TOPIC: Isolation Transformer
IDENT NO: 10-001
SUPERSEDES: New
DATE: July 15, 2006

SUBJECT: Isolation Transformer - Digital Timing/Tach Indicator Issues

MODELS AFFECTED: F1/F2 Units

Figure 1. Digital Timing/Tach Indicator

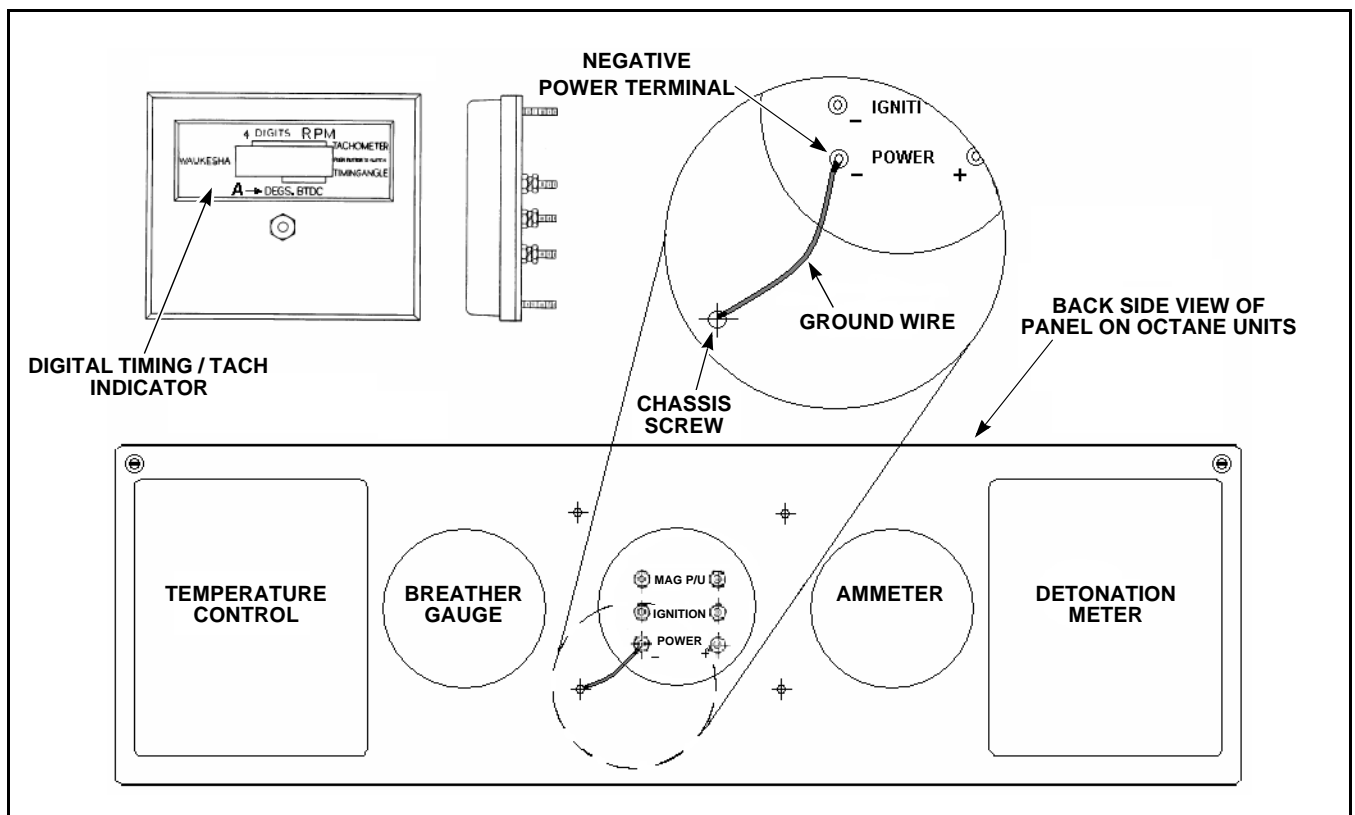
Overheating can be caused by grounding issues with the Digital Timing/Tach Indicator (P/N 111697). The isolation transformers inside the instrument panel may overheat and melt the transformers plastic casing. As a result, the Tach indicator will display incorrect timing or not function at all.

The solution to prevent these problems (or similar ones) is to remove the ground wire between the negative power terminal and the chassis.

1. Verify unit is in OFF position. Turn OFF main power to unit.
2. Open instrument panel by lifting front cover.
3. Locate negative power terminal on back of Digital Timing/Tach Indicator. Unscrew terminal and remove ground wire (see Figure 1).
4. Tighten negative power terminal after ground wire is removed.
5. Unscrew chassis screw and remove opposite end of ground wire.
6. Tighten chassis screw.
7. Discard ground wire and close panel.
8. Turn ON main power to unit.
